SERVICE BULLETIN

Machines/Models: SL-14

SERVICE BULLETIN: 94.2, THE INSTALLATION OF THIS KIT IS MANDATORY!

PURPOSE: Notification of requirement to replace latch plate weldment and instructions for replacement.

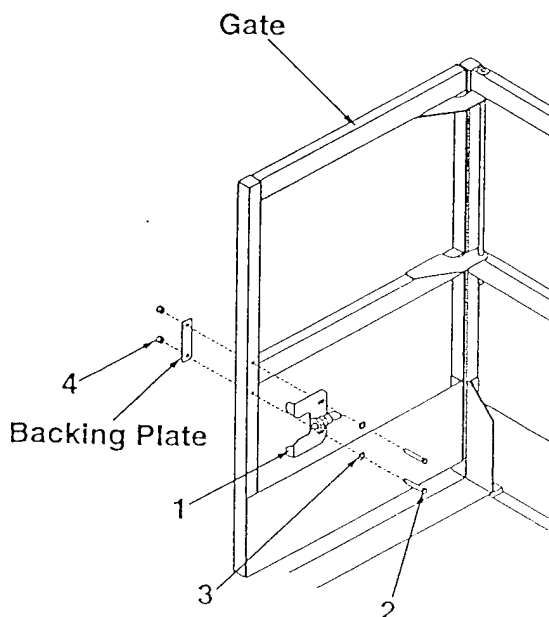
1. Remove existing latch plate weldment and fasteners and discard.
Save the backing plate for reuse.

2. Install kit 30693-000 as shown in drawing.
Kit includes; Item 1, Latch Plate Assembly
Item 2, $\frac{5}{16}$ x 2 $\frac{1}{4}$ Hex Hd Screw (2)
Item 3, $\frac{5}{16}$ Flat Washer (2)
Item 4, $\frac{5}{16}$ Hex Nut (2)
